Request for Additional Information
Model No. Traveller
Docket No. 71-9297

By application dated April 1, 2004, Westinghouse Electric Company requested a Certificate of Compliance for the Model No. Traveller package. This request identifies additional information needed by the Nuclear Regulatory Commission staff (the staff) in connection with its review of the safety analysis report (SAR). The requested information is listed by chapter number and title in the SAR. NUREG-1609, "Standard Review Plan for Transportation Packages for Radioactive Material," was used for this review. This request describes information needed by the staff for it to complete its review of the SAR and to determine whether the applicant has demonstrated compliance with regulatory requirements.

Figure 2-1A Sample of Clamshell Accelerations Measured During Road Test (May 11, 2004)

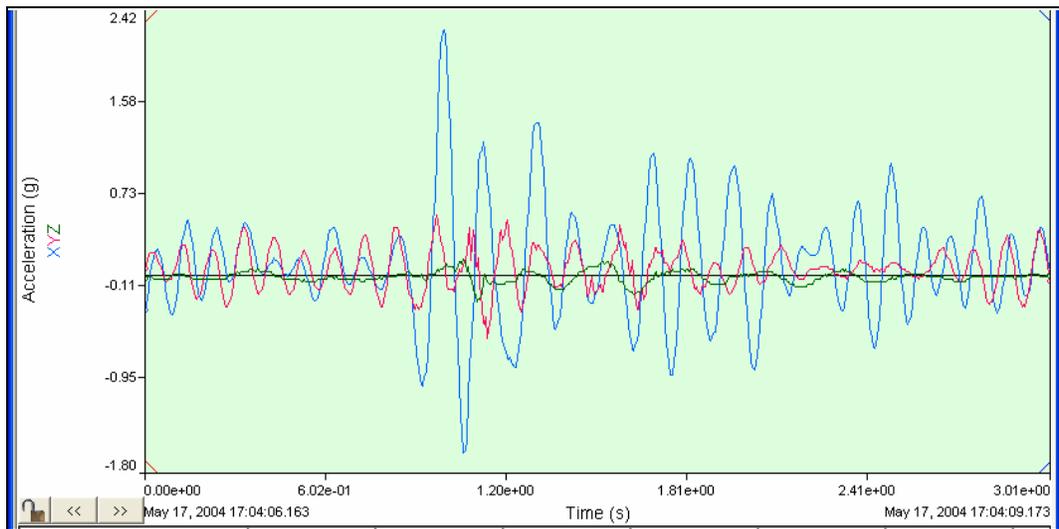
- 2-3 Revise Section 2.6.5 to include an evaluation of vibration frequencies of the Clamshell-shock mount system to ensure that no resonant vibration conditions could occur yet result in damage to the Clamshell and its contents during normal conditions of transport.

There are several natural frequencies of the shock mount system depending on direction of movement. The dominant frequency is for vertical movement. This frequency is between 5.9 and 6.7 Hz (for Traveller XL) depending on the weight of the fuel assembly being transported. The fore and aft pitch frequency is slightly higher (6.9-7.9 Hz) but has a lower amplitude. Road tests have been performed with the suspension system to measure amplitudes during shipping. Figure 2-1A is characteristic of the results seen. When the truck travels over a bump, the clamshell initially sees relatively large accelerations (2-3 g's) but this oscillation quickly damps out to accelerations less than 1g. This 300 mi trip involved approximately five and a half hours on the road with 1.4×10^5 total cycles.

Figure 2-1B Impact Limiter "Pillow" Assembly

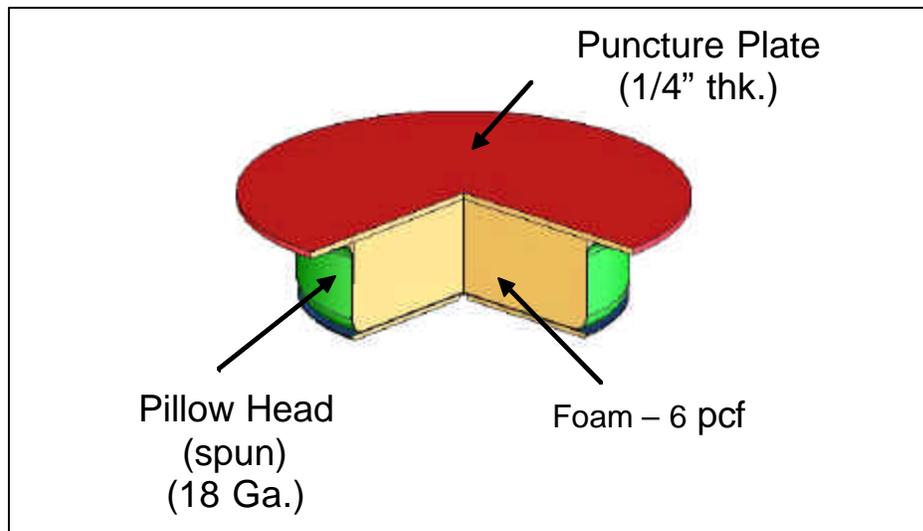
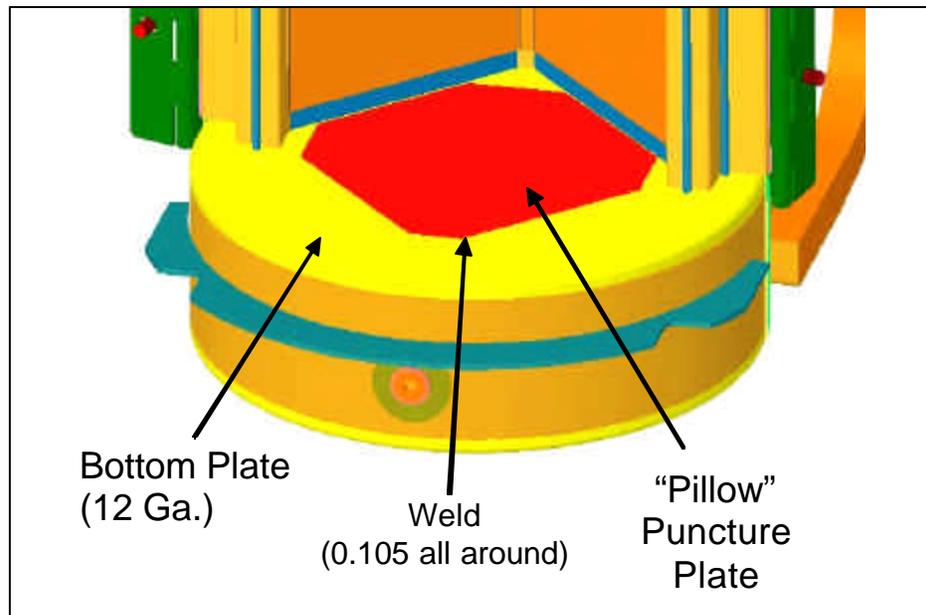
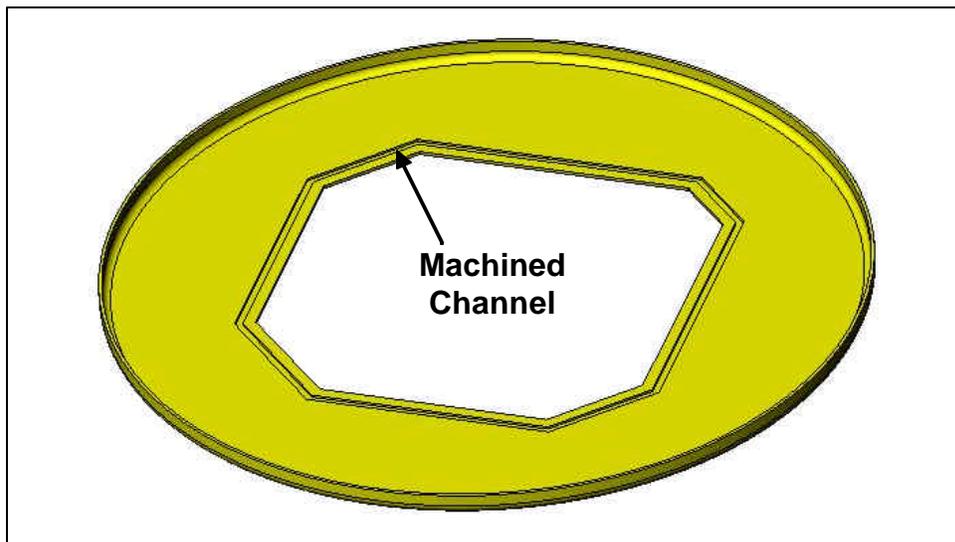
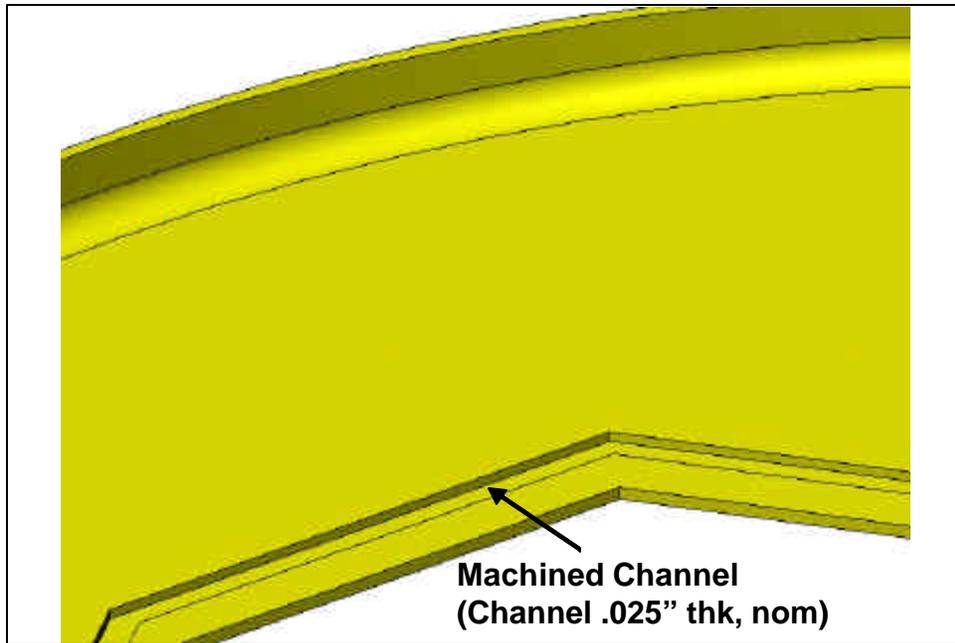
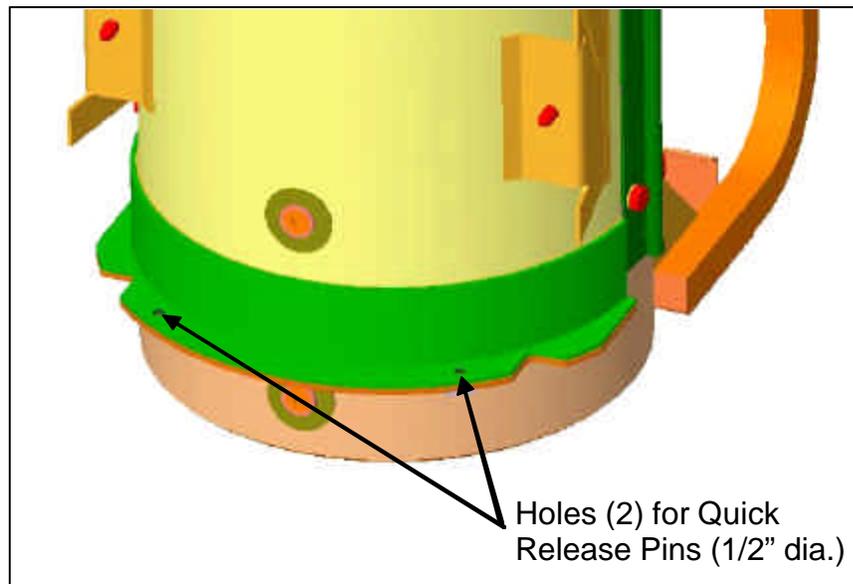
- 2-5 Provide drawing details for the design changes introduced to the Certification Test Unit drop tests to improve performance of the package, including welding of the impact limiter pillow to

the Outerpack liner plate and modification of the quick release pin. Changes to the packaging features that are important to safety should properly be presented in design drawings (Table 2-5, Page 2-22).

The figure below (Figure 2-1B) shows the impact limiter, or Pillow, assembly (shown without insulation). This assembly is shown installed in the Traveller package bottom (the configurations are the same for STD and XL packages) in Figure 2-1C. The weld between the bottom plate (yellow) and the puncture plate (red) is also shown. During testing this weld failed as expected, however, it did not completely allow the components to separate. This design change weakens the bottom plate by reducing its thickness to a nominal 0.025" thickness, as shown in Figures 2-1D and 2-1E. A .25 inch wide channel was added to weaken the part.

The CTU design included a pinned connection (2 quick release pins – 0.5" diameter) between Outerpack halves at the bottom end of the package. Quick release pins were designed to help prevent the halves from warping and opening a gap locally during fire testing. Figure 2-1F shows the location of the quick release pins. During drop testing, the pins failed, therefore, they could not be used in the fire testing.

Figure 2-9 Weld Geometry at Swing Bolt Block

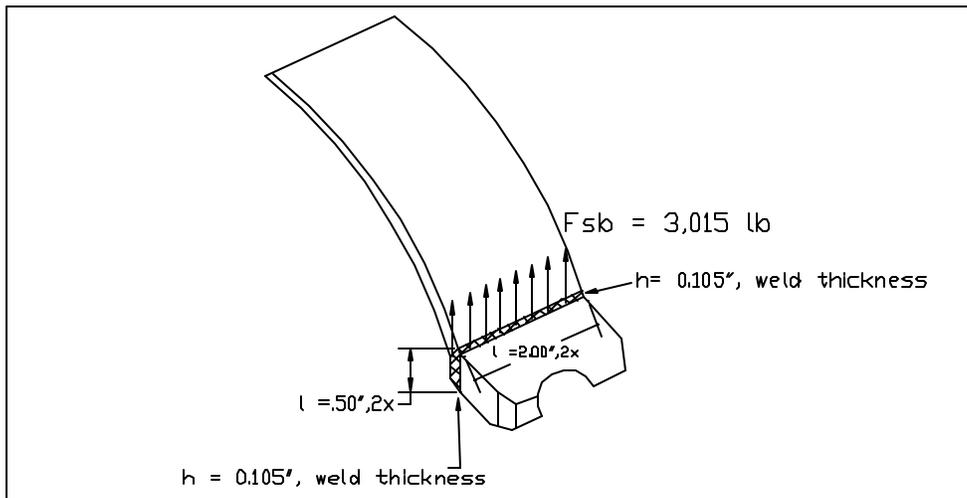
- 2-7 Provide drawing details for the swing bolt block, as identified in Figure 2-9, used for the alternative lifting configuration. The swing bolt block depicted in Figure 2-9 lacks sufficient detail to enable proper evaluation of its structural capacity.

Figure 2-9 has been revised as follows:

Figure 2-100 Outerpack Mesh in Qualification Unit Model

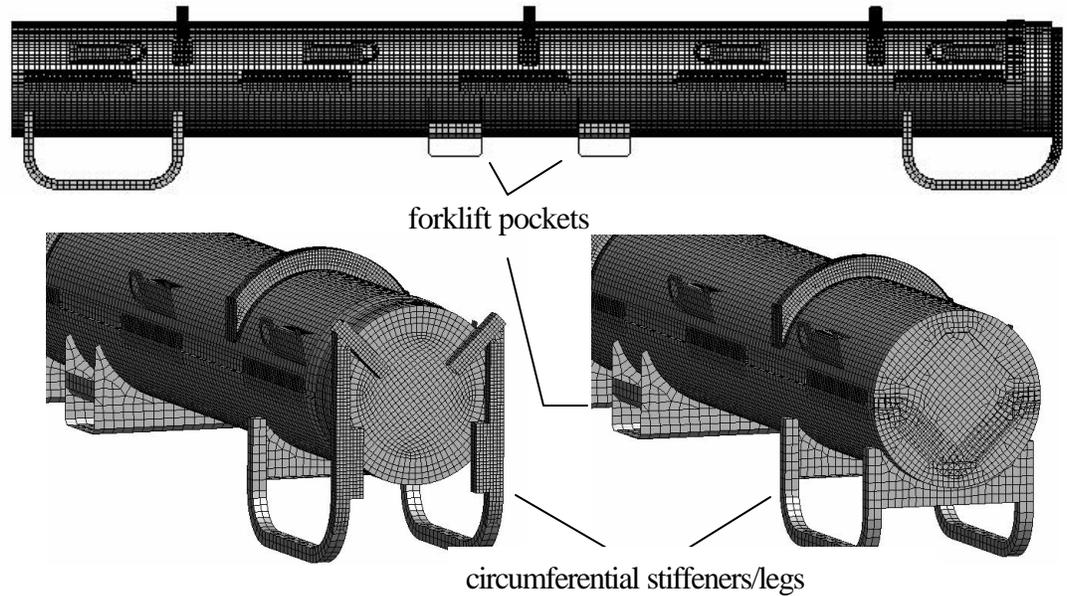
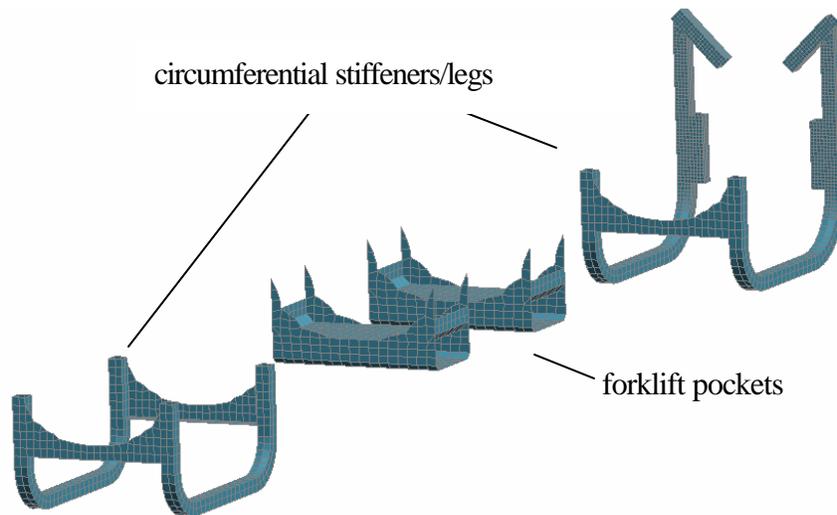
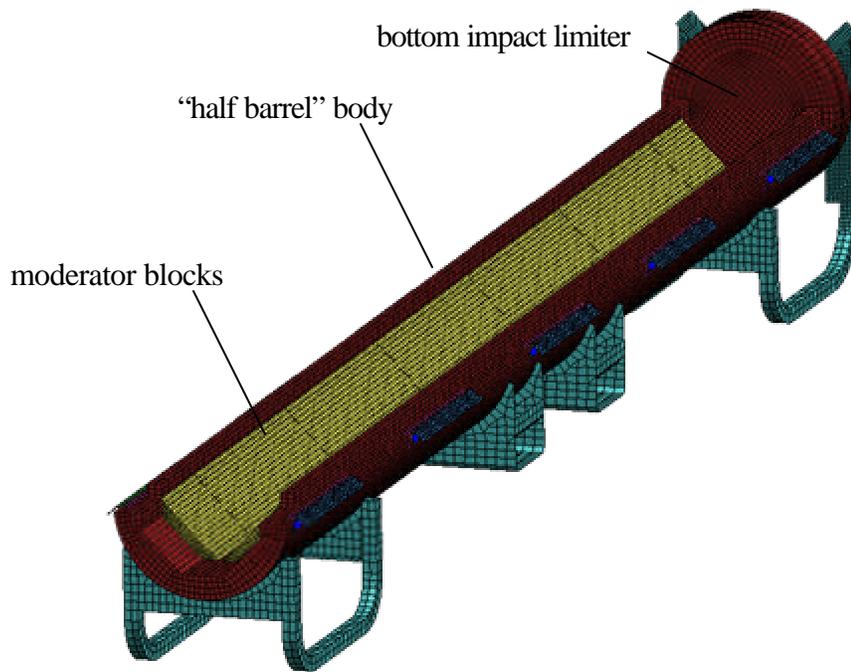
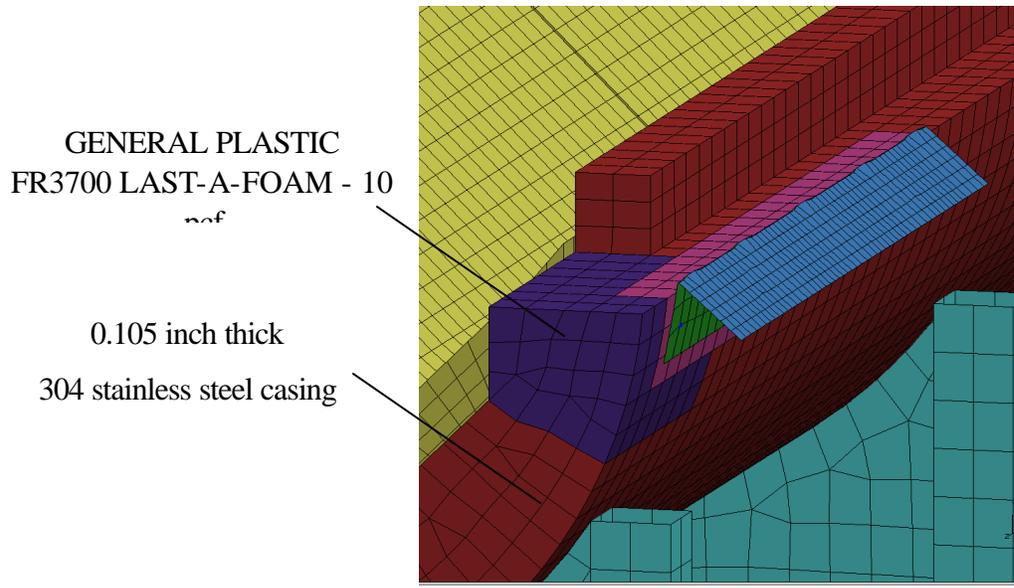
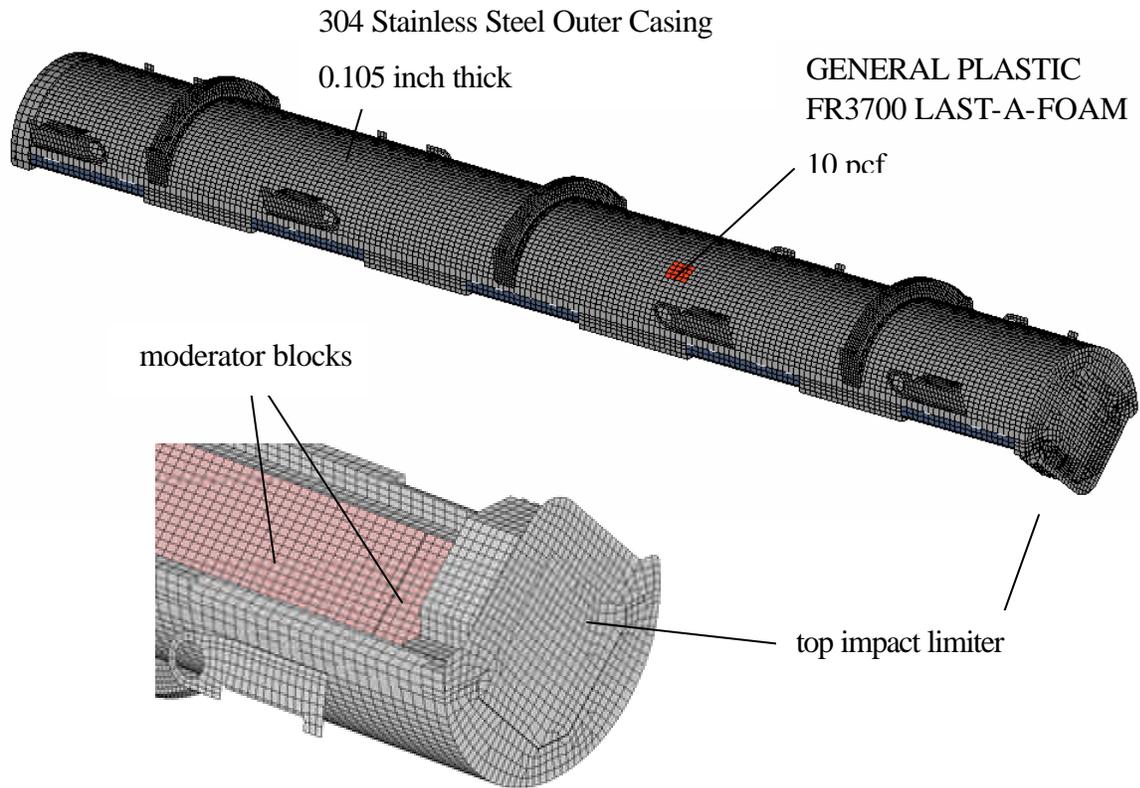
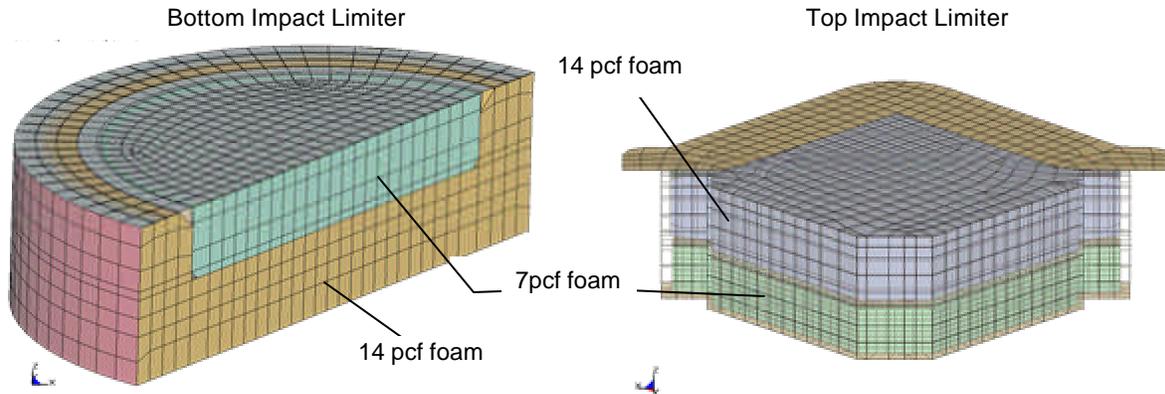
- 2-10 Revise Section 2.12.3, to include illustrations in sufficient detail for the finite element analysis (FEA) models of individual package parts and their interfaces. Also, revise the application to include descriptions of modeling parameters, such as element types, material types and associated state equations, and boundary conditions from which the calculated drop accident responses can be properly evaluated.

The circumferential stiffeners/legs and forklift pockets (Figure 2-100A) were modeled using 4-node Belytschko-Tsay shell elements (LS-DYNA elform = 2). These elements were integrated at three locations through the thickness using Gaussian quadrature. 1,008 of these elements were used to model the forklift pockets and 4,436 were used modeling the legs.

The FE model of the QTU lower outerpack is depicted in Figures 2-100B and 2-100C. In addition to the previously mentioned circumferential stiffeners/legs, the lower outerpack is comprised of a long thick-walled “half-barrel” body and an impact limiter attached to one end (Figure 2-100A). The “half barrel” body is a sandwich construct of 10 pcf foam encased in 0.105 inch thick 304 stainless steel (Figure 2-100C). The outer steel casing was modeled using the same element formulation and integration scheme used for the circumferential stiffeners/legs. 19,516 elements were required. The 10 pcf foam was modeled using 8 node selectively reduced fully integrated solid elements (LS-DYNA elform = 2) in conjunction with a material formulation developed especially for crushable foam (LS-DYNA material type = 63). Modeling the 10 pcf foam in the lower outerpack required 36,617 elements. Since this foam was poured-in-place, it is adhered to

The FE model of the QTU upper outerpack is depicted in Figure 2-100D. It primarily consists of a long thick-walled “half-barrel” body and an impact limiter attached to one end (Figure 2-100D). The “half barrel” body is a sandwich construct of 10 pcf foam encased in 0.105 inch thick 304 stainless steel. The outer steel casing was modeled using the same element formulation and integration scheme used for the circumferential stiffeners/legs and lower outerpack casing. 18,634 elements were required. The 10 pcf foam was modeled using 8 node selectively reduced fully integrated solid elements (LS-DYNA elform = 2) in conjunction with a material formulation developed especially for crushable foam (LS-DYNA material type = 63). Modeling the 10 pcf foam in the lower outerpack required 36,094 elements. Since this foam was poured-in-place, it is adhered to the stainless steel casing. This was modeled by enforcing tied contact between the outer nodes of the foam and the casing. The moderator blocks in the upper outerpack were modeled using 26,368 constant stress solid elements (LS-DYNA elform = 1). Linear elastic material properties were used. The moderator blocks were attached to the upper outerpack using four bolts each for the full length moderator sections and two bolts each for the half-length moderator sections at the ends. These bolts were modeled using beam elements (LS-DYNA elform = 9) with a “spot weld” material formulation (LS-DYNA material type = 100). Contacts between the moderator blocks, the upper outerpack, and the clamshell were defined using a penalty-based contact algorithm as described for the lower outerpack.

Model details of the impact limiters are shown in Figure 2-101. Both consisted of two separate foam pieces: a 7 pcf foam block was placed inboard nearest the clamshell and 14 pcf foam covered both ends of the overpacks. These foam pieces were separated and covered by stainless steel. The foams were modeled using the same element formulation and material model as described for the 10 pcf foam in the overpack “barrels” except that each foam density had its own stress-strain curve. The 7 pcf foam in the bottom impact limiter was modeled with 2112 solid elements; the 14 pcf foam was modeled with 4480. The 7 pcf foam in the top impact limiter was modeled with 5248 elements; the 14 pcf foam was modeled with 1755 elements. Because these foams were “cut-to-fit,” they were not bonded to the steel cases. Thus, contact between the steel casings and the foam was defined using LS-DYNA’s AUTOMATIC_SINGLE_SURFACE contact algorithm as previously described (for contact between the lower outerpack, moderator blocks and clamshell).

Figure 2-102 Clamshell Mesh in Qualification Unit Model

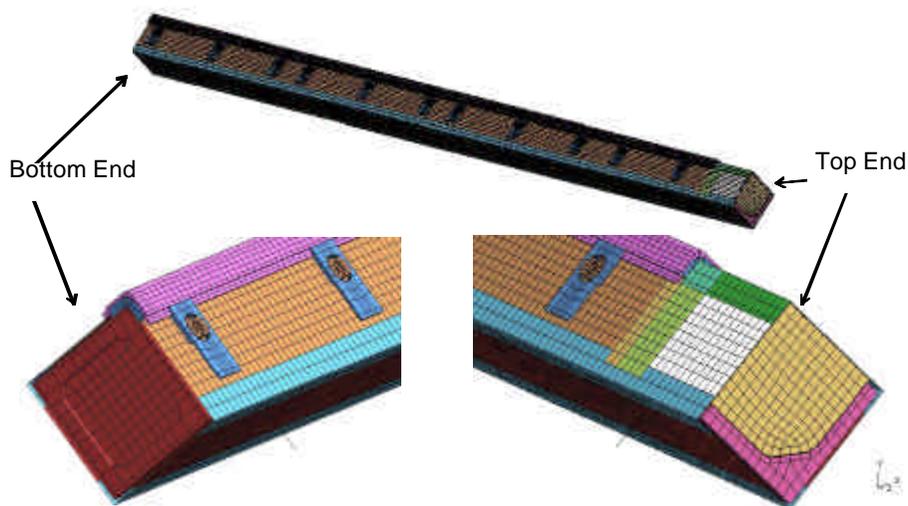
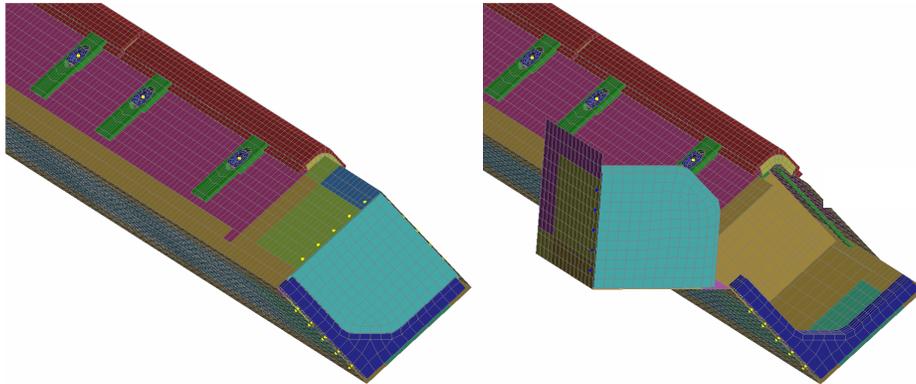
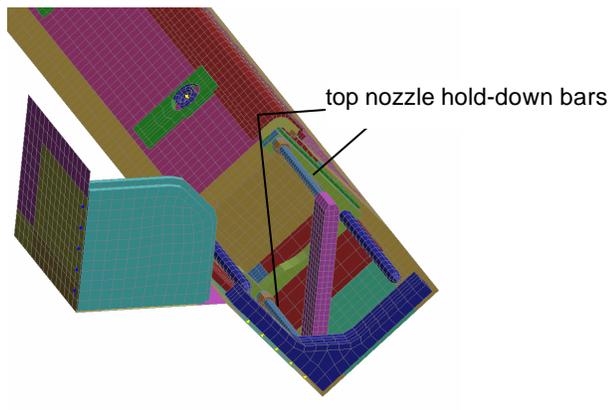
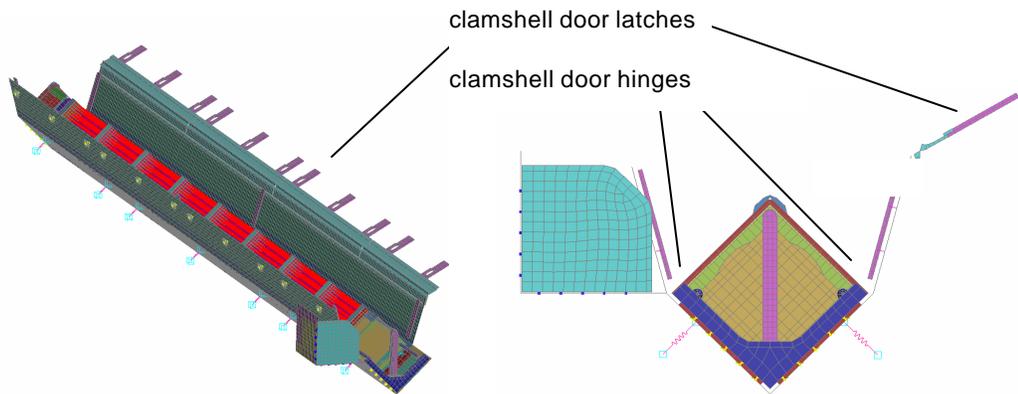
- 2-20 Verify that appropriate finite element Clamshell models were used in the analysis of the Qualification Unit drop test. The staff notes that modeling attributes, including element meshes, are markedly different for the same Qualification Unit Model shown in the two plots, Figures 2-96 and 2-102. It is not clear from the information provided which Clamshell model was used in the analysis.

The clamshell design did evolve during its development. The final design is reflected in Figure 2-102 and all analyses reported in the SAR utilized the clamshell model depicted in this figure.
